From: "Mark Reynolds" <cwmining@etv.net>
To: <PRISCILLABURTON@utah.gov>
Date: 9/6/02 8:16AM
Subject: FW: Wild Horse Ridge Tank Seam Addition

From: Priscilla Burton [mailto:PRISCILLABURTON@utah.gov]
Sent: Wednesday, September 04, 2002 2:50 PM
To: mark_reynolds11@excite.com
Cc: Mike Suflita
Subject: Wild Horse Ridge Tank Seam Addition

SCALE: 1" = 500'	DRAWN BY: C. Reynolds	DATE: 9-05-02
BEAR CANYON		PLATE 3-4A

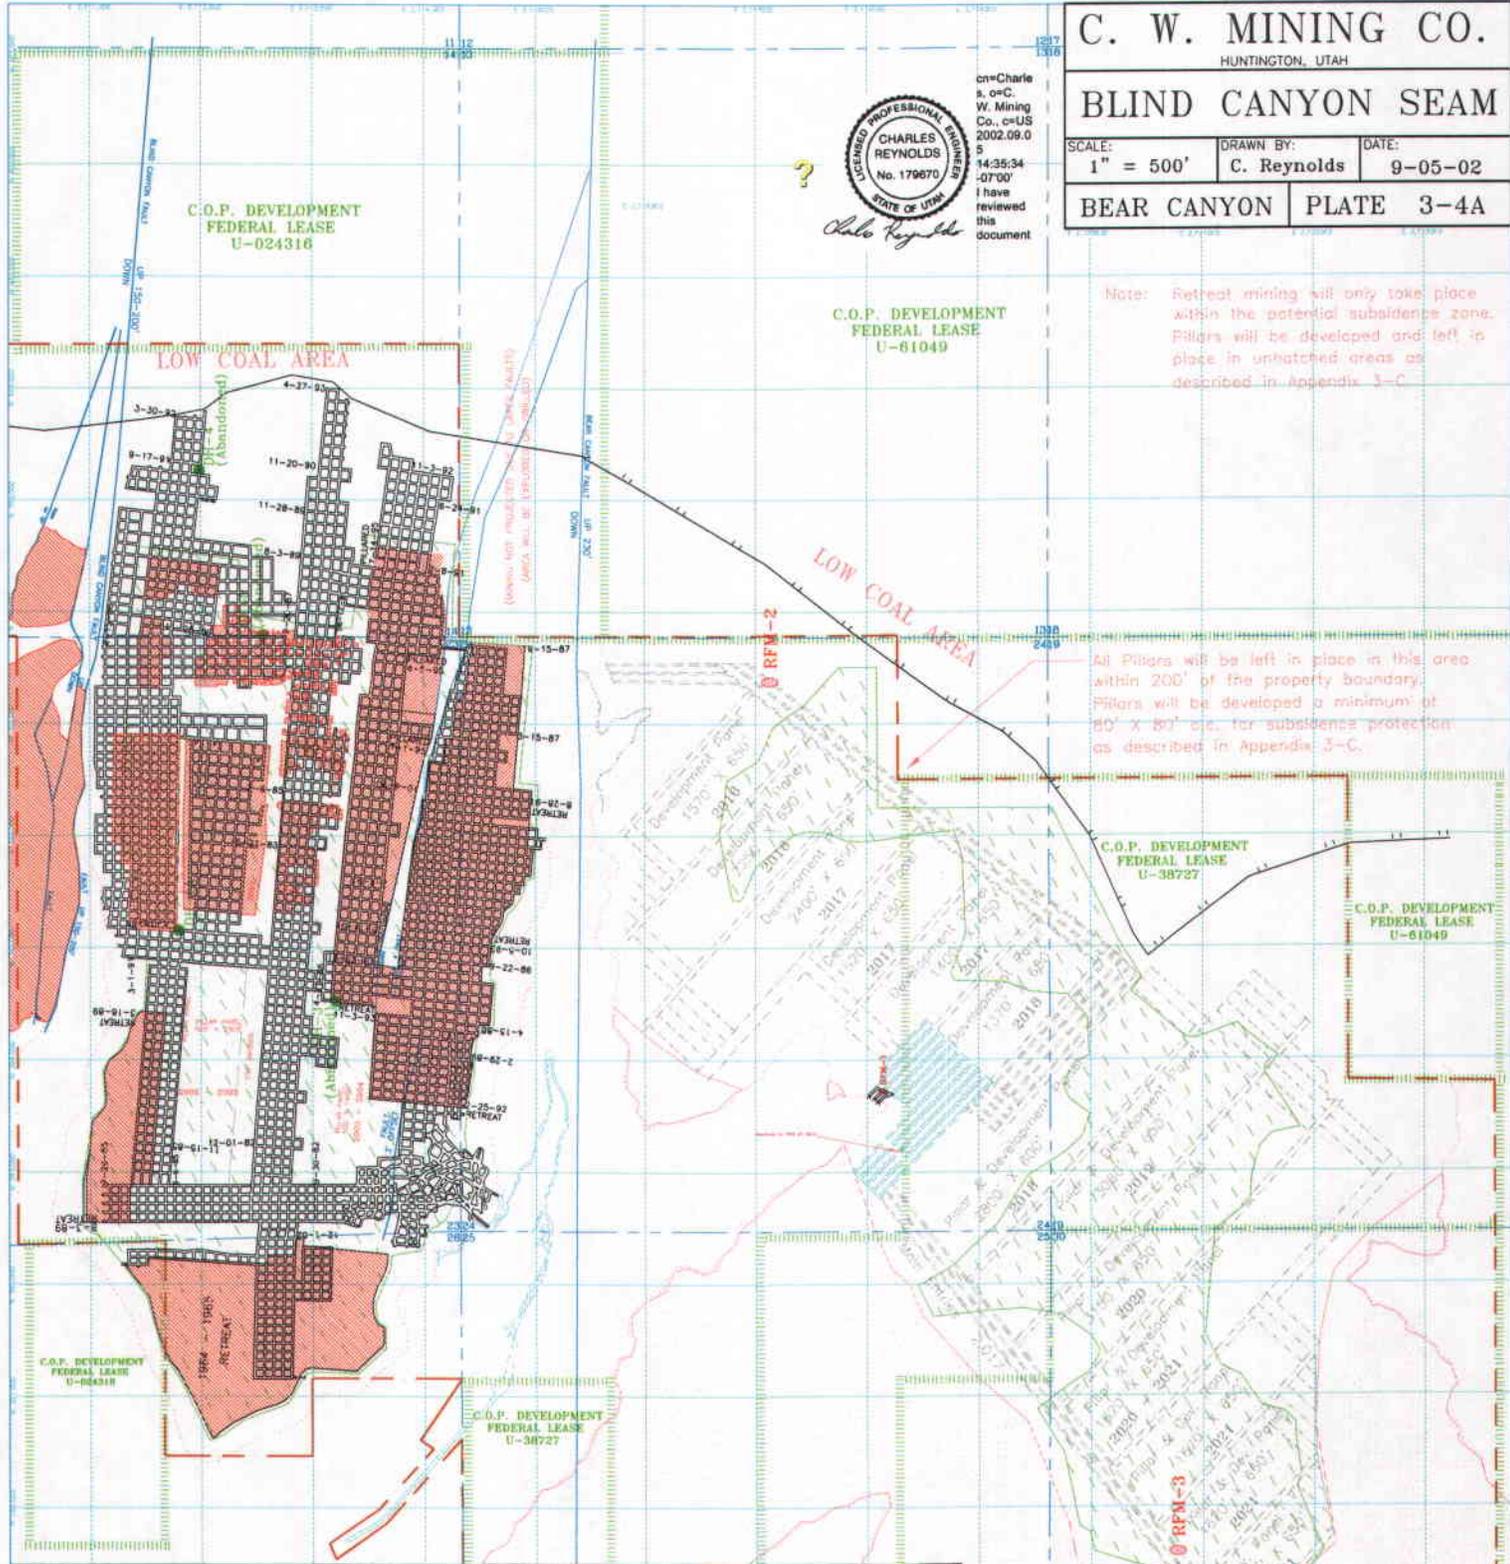
Once I looked at the 3-4A map included in the annual report I could understand your confusion. Not only did we not add the #3 Mine area, but we forgot to move the location of RFM-1 and RFM-2. The map I was looking at while I was talking to you was a lot different than yours. The area where we were showing the sites are low coal areas. This new map should clarify things for you. I have also increased the scale of the map to make it easier to read.

We just spoke on the telephone about the sampling locations. I have one more question. I see that RFM-4 is located on Plate 3-4c.pdf. Looks like this point was encountered in 2001. Was this site sampled? It would have been in the Tank Seam, right?

Concerning RFM-4 you must have really good eyes to read that number and those dates. The site was not encountered in 2001. It was encountered in 1995 and then the pillars were pulled in 2001 and 2002. Charles says he collected the samples for the site himself. I will try and find the results from those tests for you.
